## Takoma Park Public Library – Mandatory Referral No. 2021018

### Summary

### Mandatory Referral No. 2021018

Figure 6: Mandatory Referral Plan

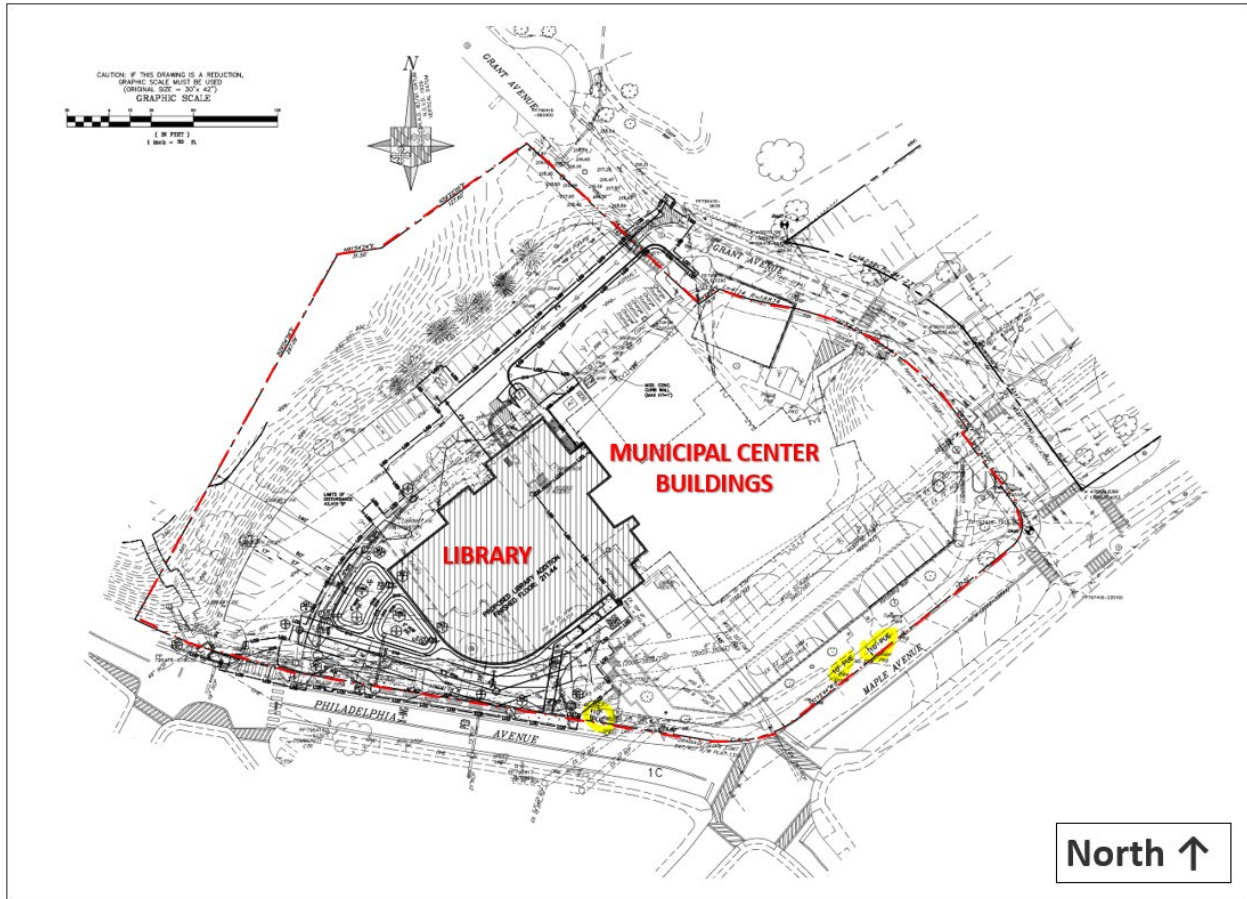
2. Enhance/emphasize the main entryway by providing a tower element or other noticeably vertical feature that can be seen from the streets and neighborhood and help mark the public entry. Suggested elements include a simple clock tower, sculptural flag tower and pole, or a vertical piece of public art. (Ideally the suggested vertical feature would be incorporated as part of the initial design but could be phased in as needed). Appropriate signage should also be provided to formally identify the facility and location of the entryway.

3. Enhance the SWM facility (which is prominently located near the intersection of Philadelphia and Maple Avenues) by incorporating recreation space, artistic conveyance of rainwater, and/or educational elements.

4. Continue to explore design changes or other opportunities to provide new street trees along the site frontages, particularly along Philadelphia Avenue.

Figure 12: Access and Site-Circulation

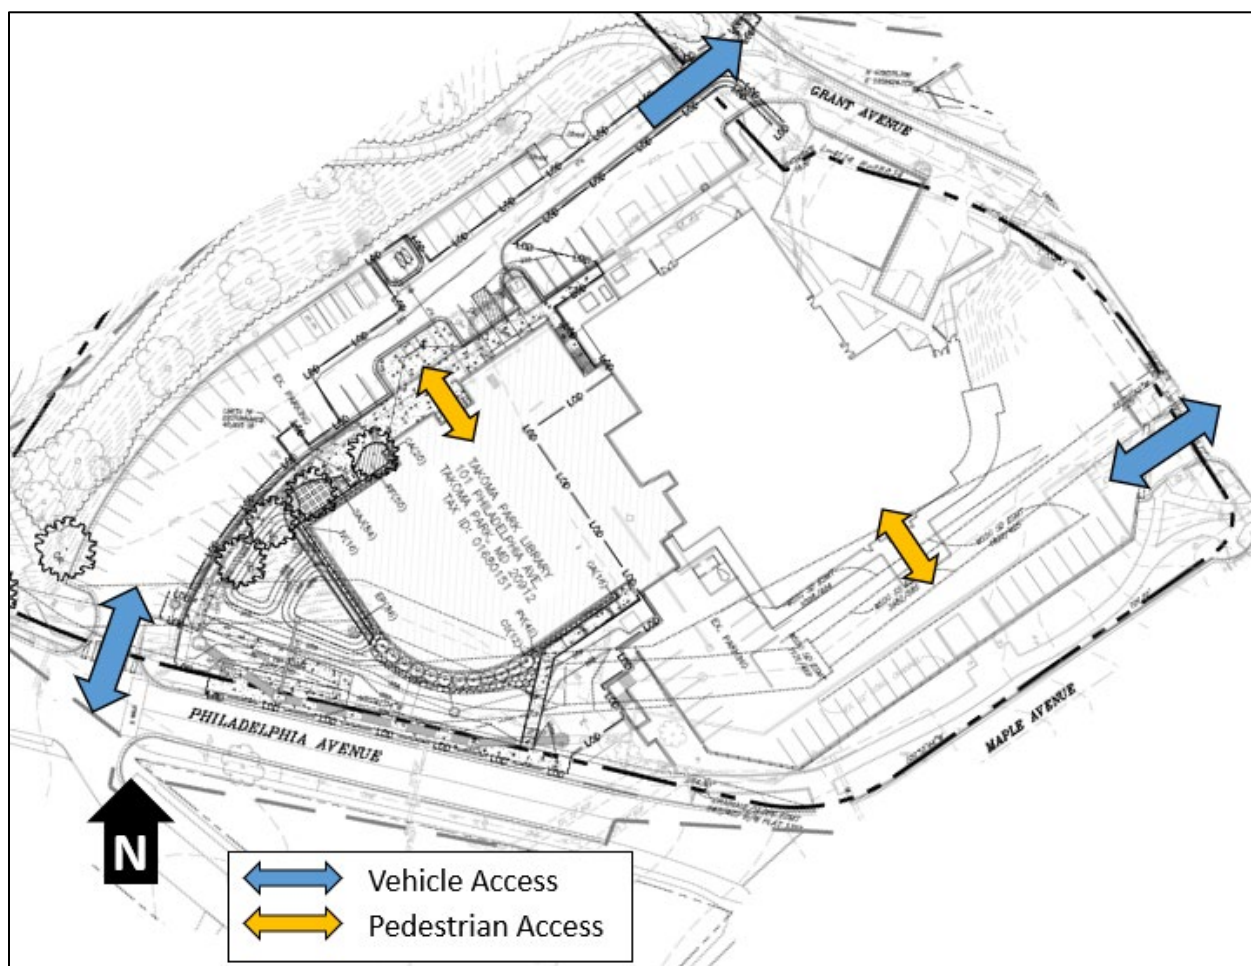
- a. Sidewalks along the Philadelphia Avenue frontage of the addition shall be a minimum of 6-feet wide.
- b. Sidewalks internal to the Site should be ADA accessible. A width of 6-feet is preferred.
- c. Provide attractive features such as flower beds, benches, decorative lights and seasonal banners (per the Maple Avenue Recommendations of the Master Plan page 95).

- a. Master-planned facilities: The Applicant should install the master-planned sidepath along Philadelphia Ave. Per the 2018 *Bicycle Master Plan*, the minimum width of the facility should be 10-feet in width.
- b. Bikeshare Facilities: Unless reconstructed in place, the Applicant should identify an appropriate location for the existing Bike Share station currently located at the southwest vehicular entrance of the Site, prior to use and occupancy permit.

SHEET  
**C-7A**

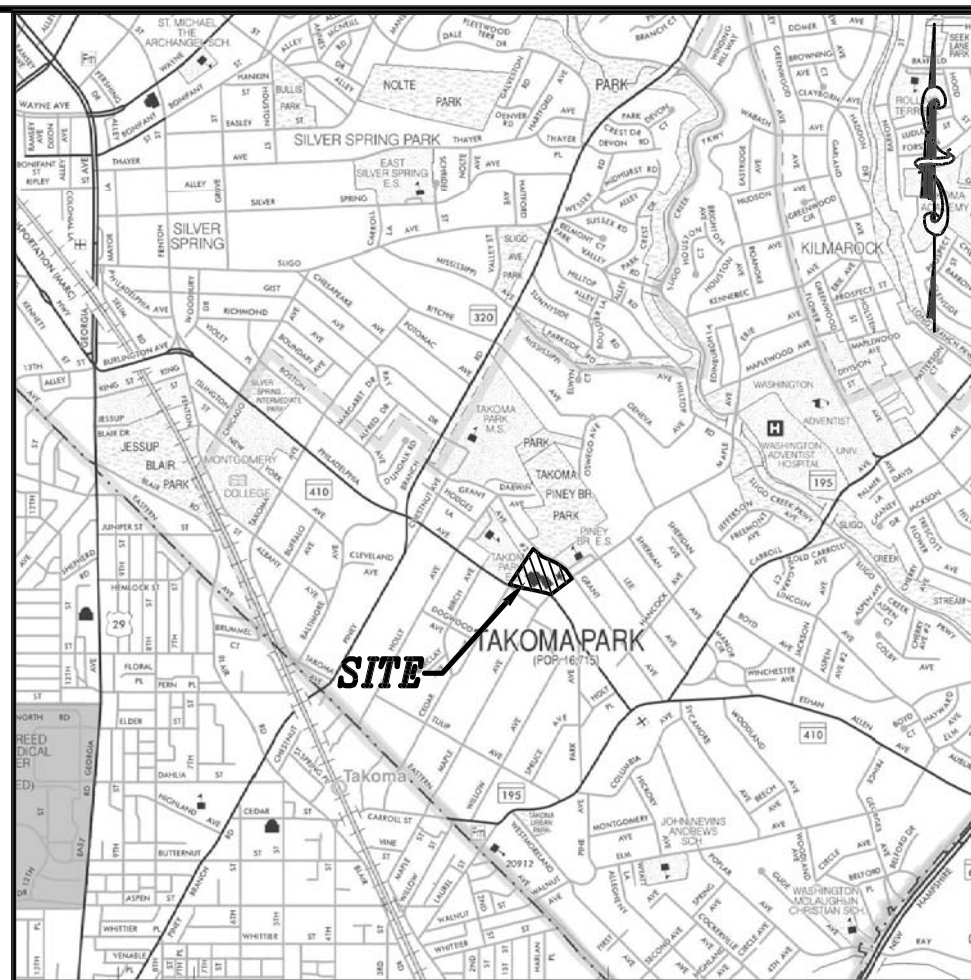
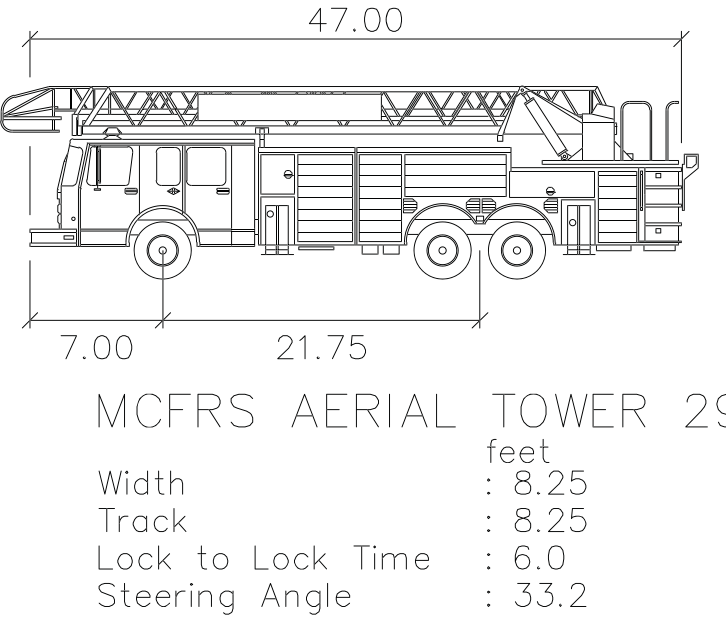
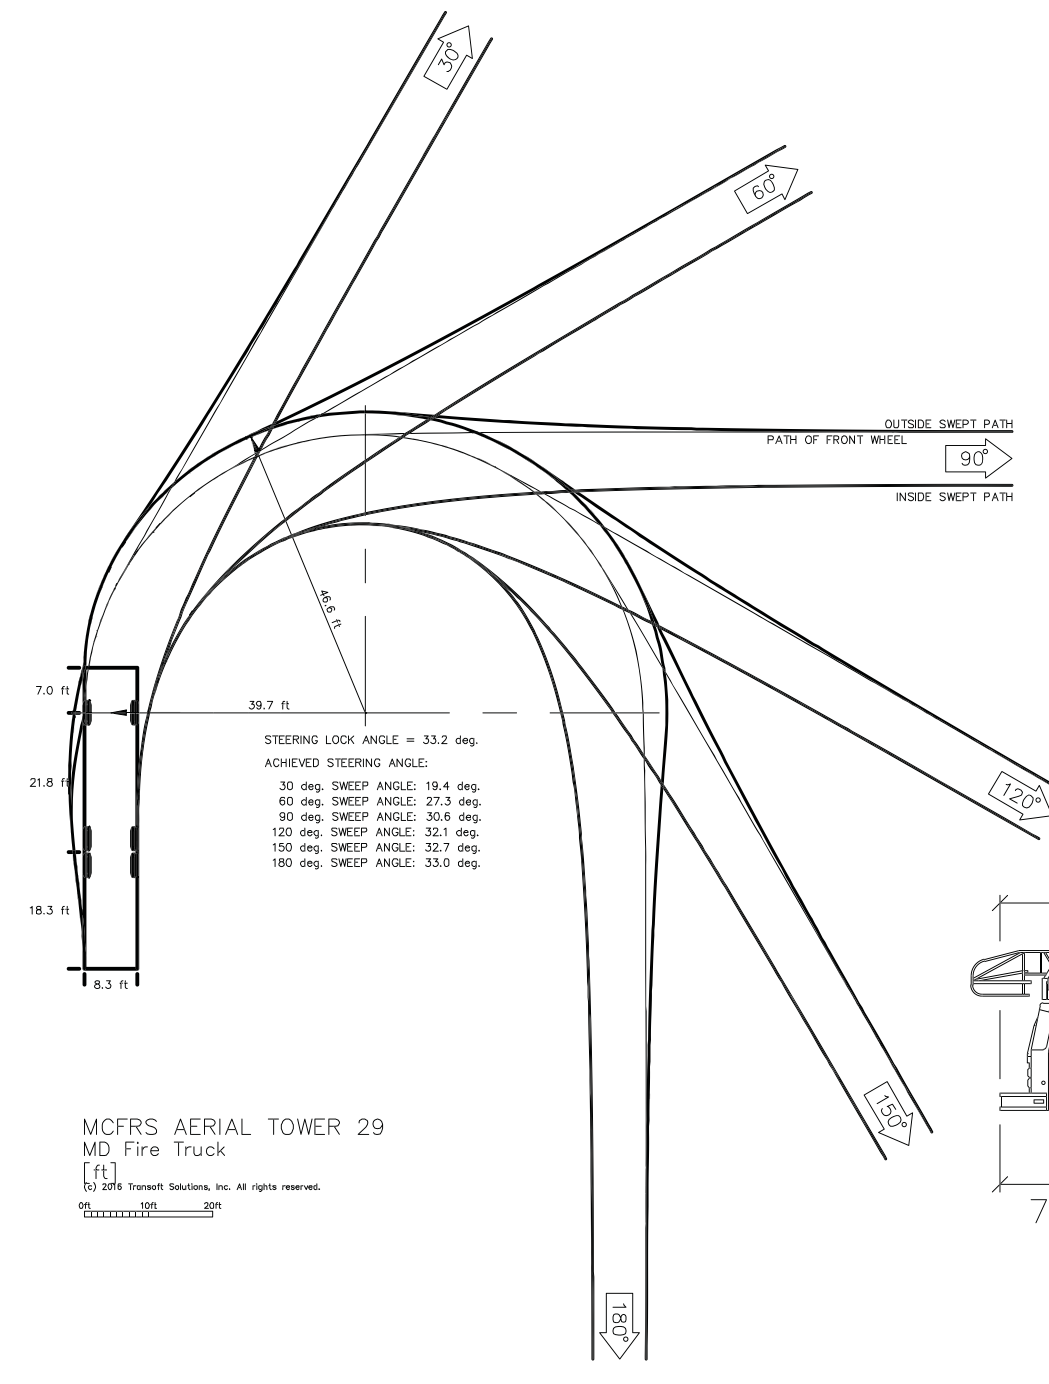
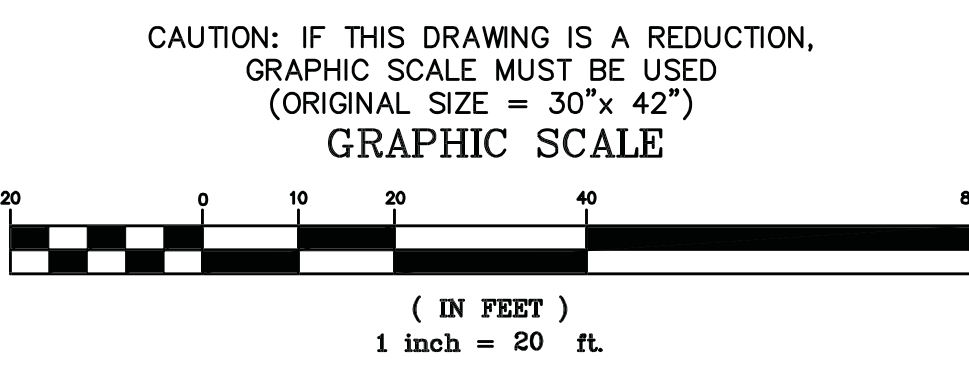
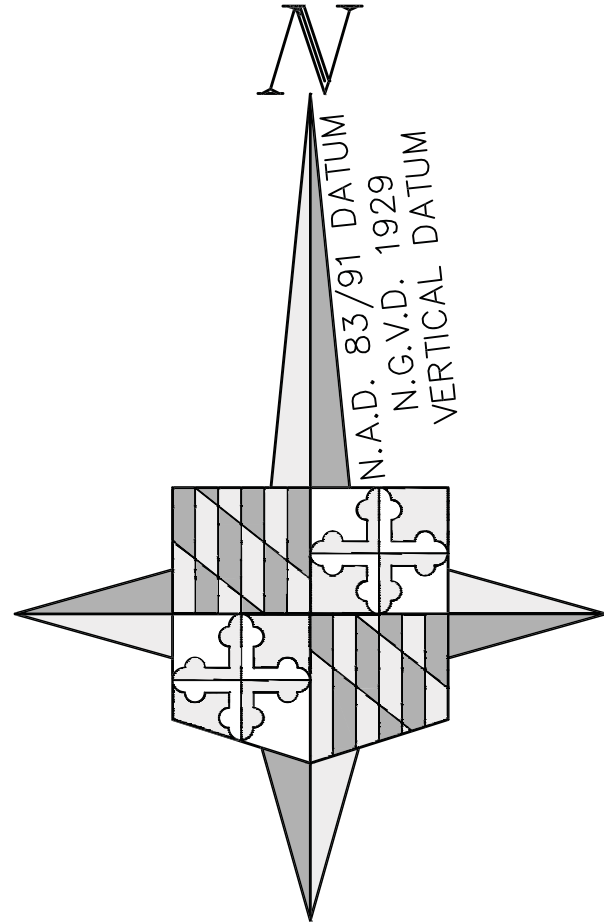
**FIRE CODE ENFORCEMENT**  
Fire Department Access Review  
Review based only upon information contained on this plan. Does not cover unsatisfactory layout resulting from omissions, errors or failure to clearly indicate conditions on this plan. Correction of such unsatisfactory layout to afford required access will be required if found upon inspection after installation.  
BY: *S.M.C.* PK: 43 DATE: 7/20/2021  
\*\*\* Library addition on existing site \*\*\*
